Planning & Zoning Board

Thursday, February 8, 2024

RE: Heart Food Pantry; 6541 E. Main Street: Major Site Plan and Variance Request

On behalf of the City of Reynoldsburg, EMH&T conducted a preliminary engineering review of the Major Site plan for the Heart Food Pantry and Market project located at 6541-6543 East Main Street. Previous reviews of the plan and traffic study were conducted in October and December of 2023. The following summarizes our findings and recommendations with respect to this development.

A WEST ELEVATION
Scale: 1/8" = 1'-0"

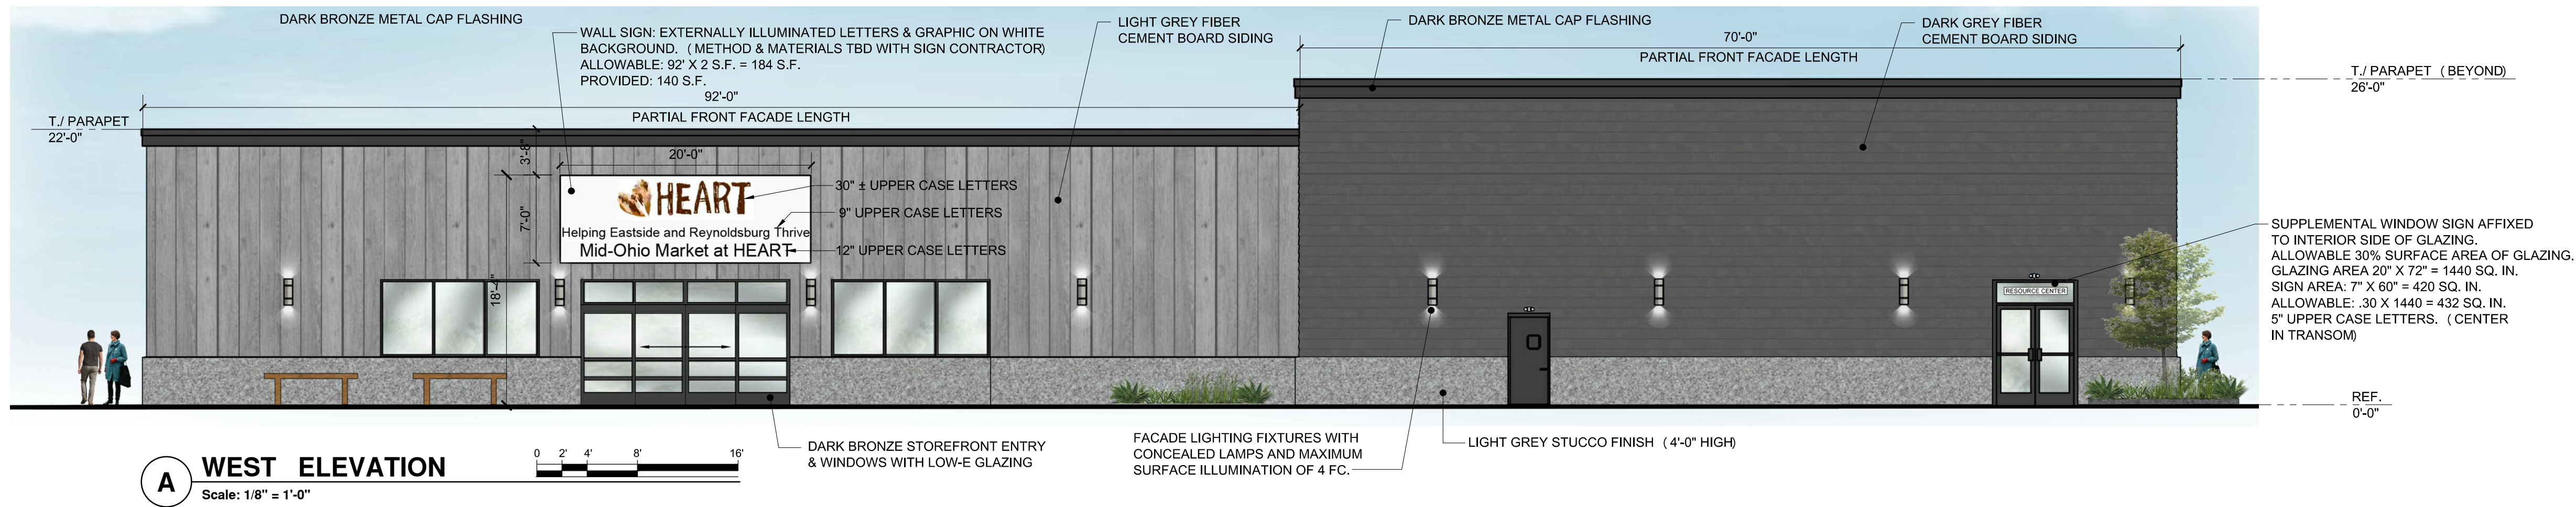
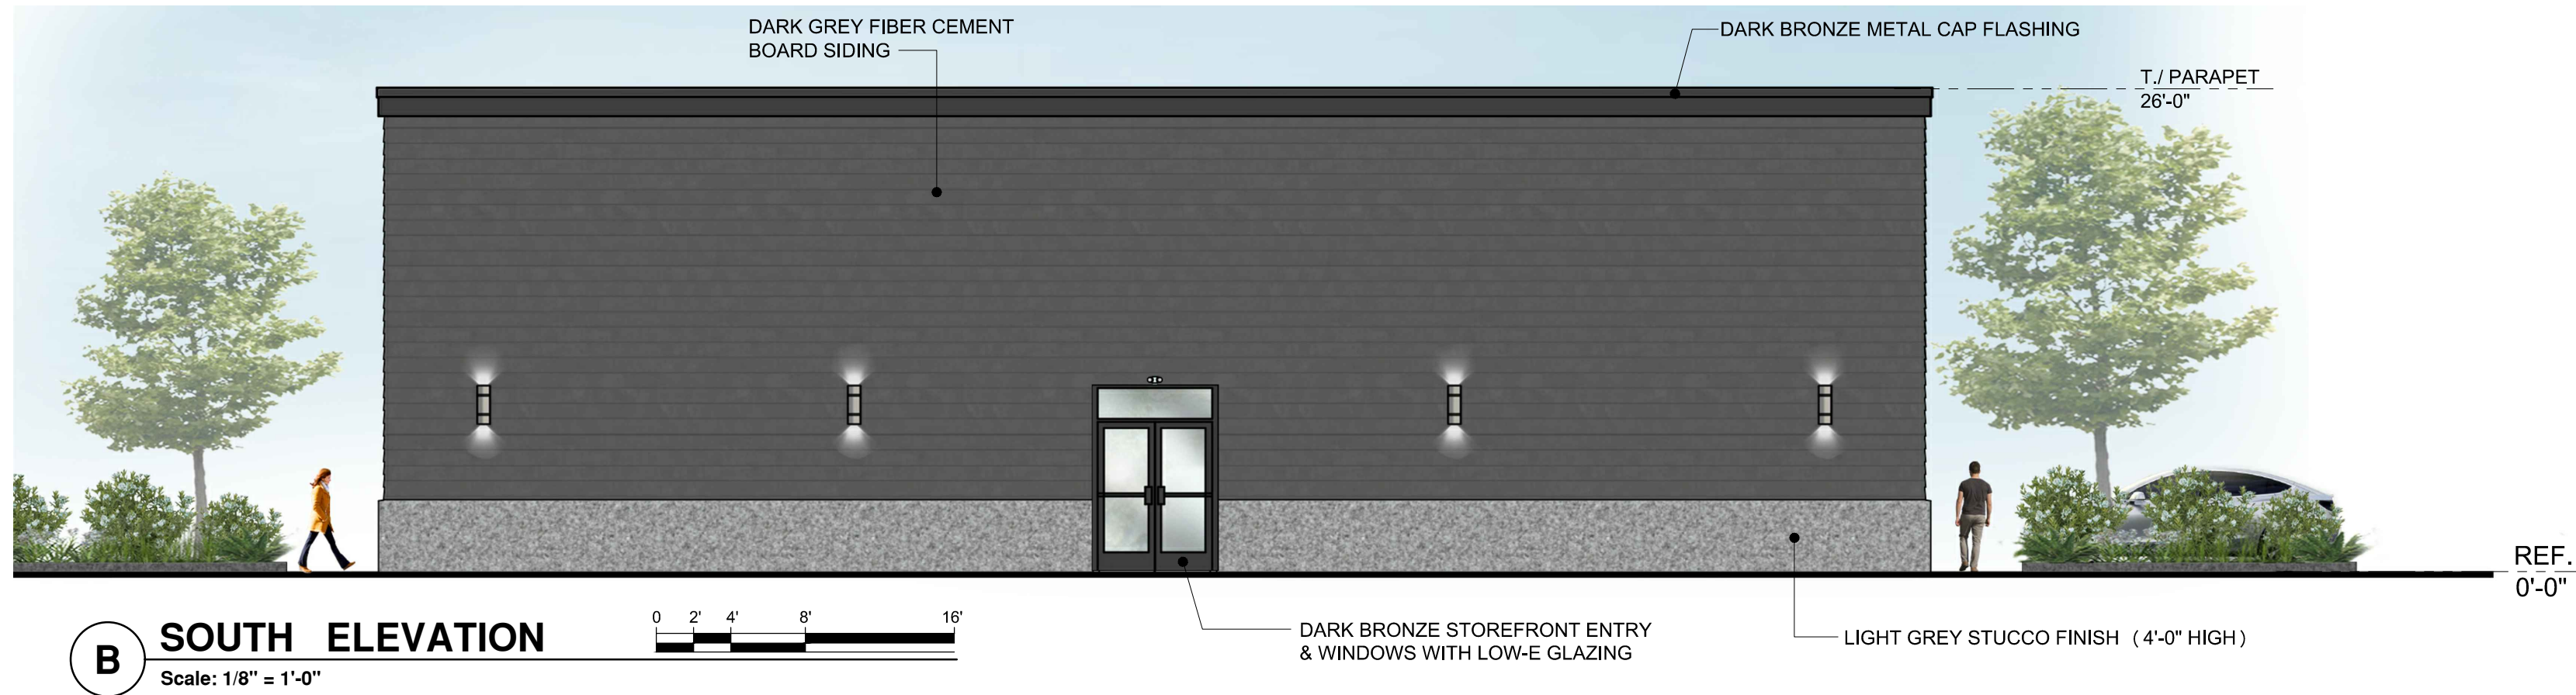
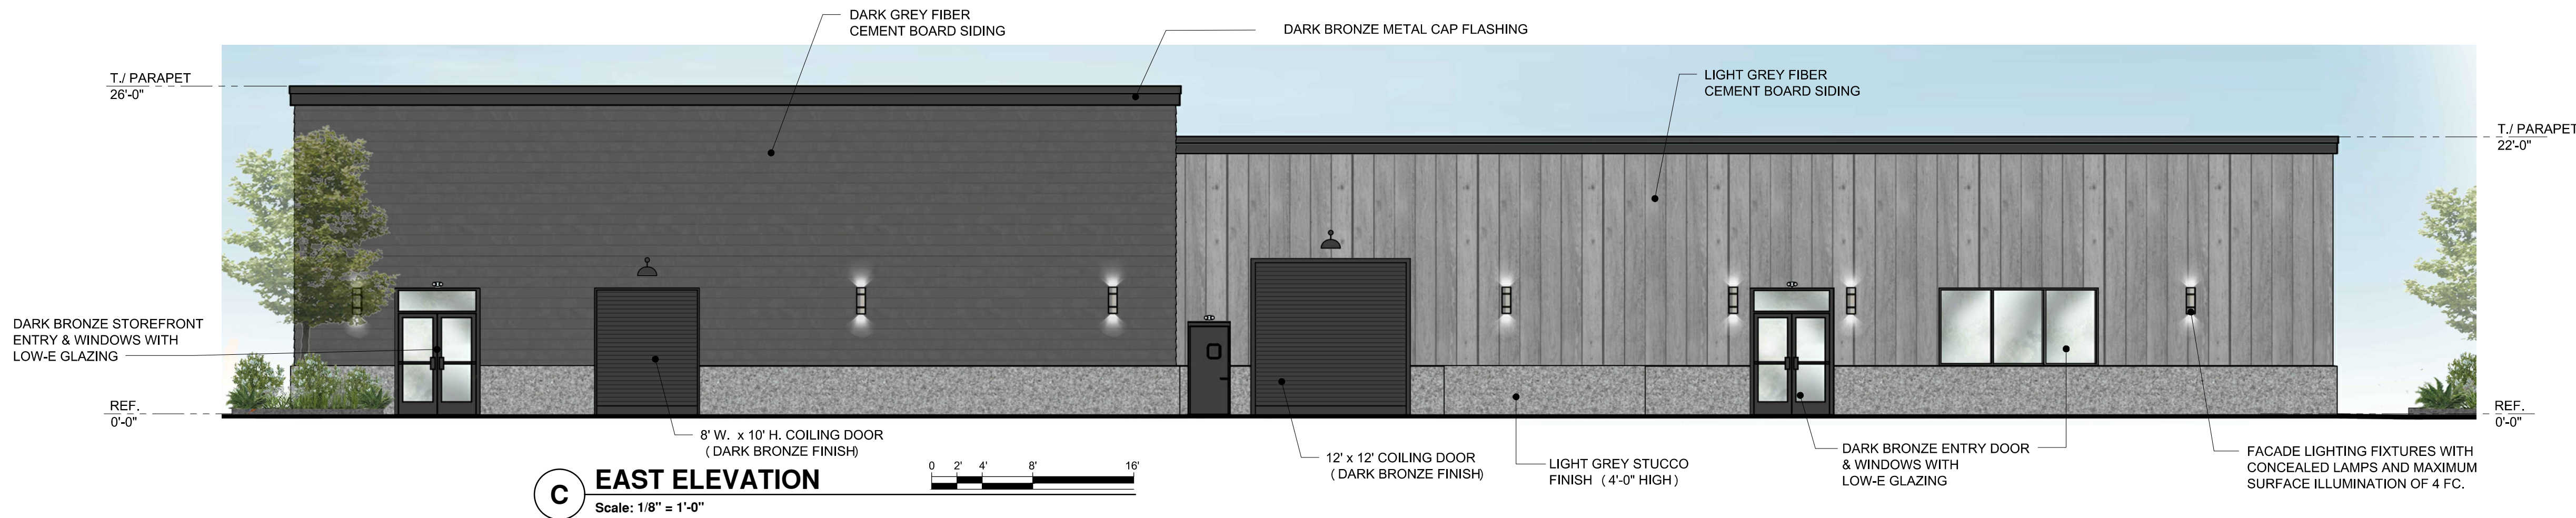
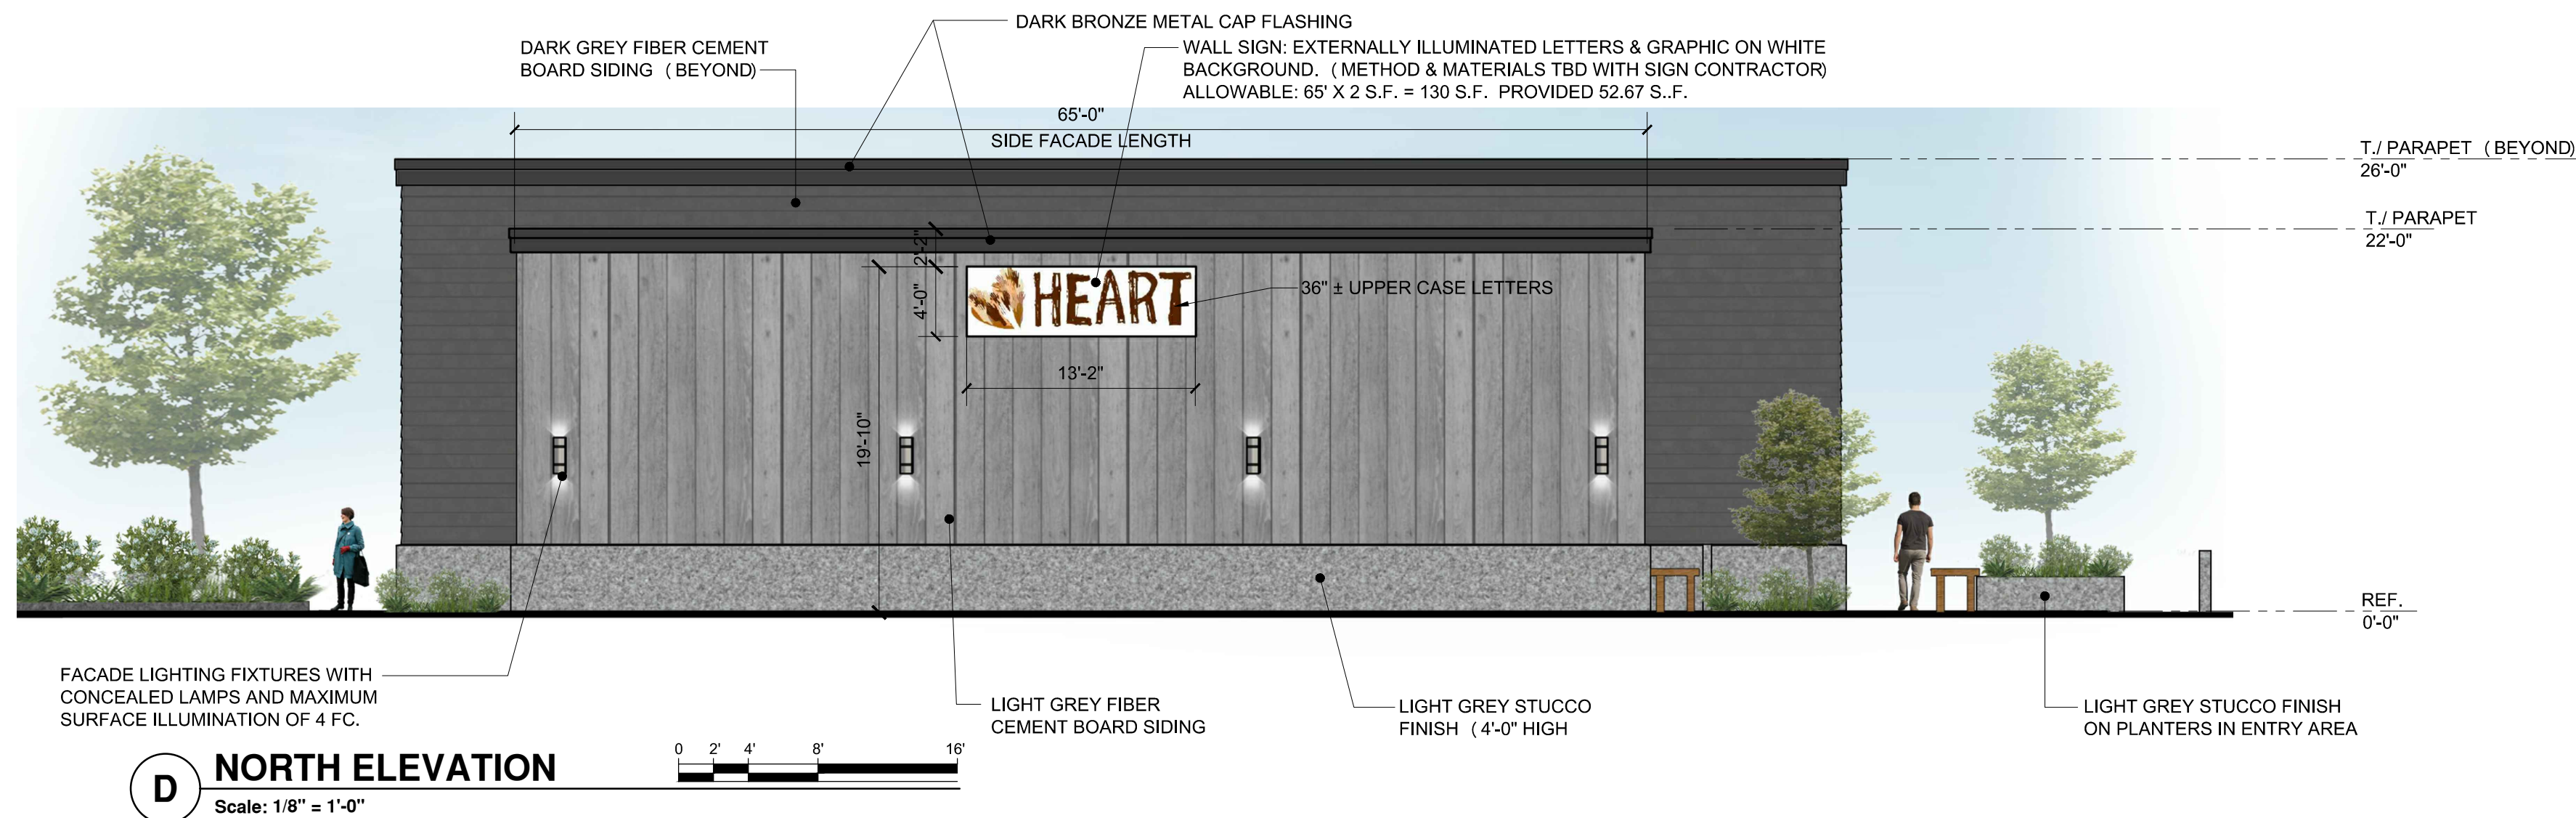
I am the engineer working on the HEART Food Pantry and I wanted to try to quickly head off a comment you made on your review. I know that per **Appendix D Section D105.2 of the OFC**, a **26' drive aisle is needed when a building exceeds 30' in height**. Based on your comment, we reduced the height of the building to 26' to the top of parapet wall. Please see the attached building elevations.

As per our conversation over the phone, with the lowering of the height of the building below 30' the widths of the drive aisle on the current plans meet the 2017 Ohio Fire Code.
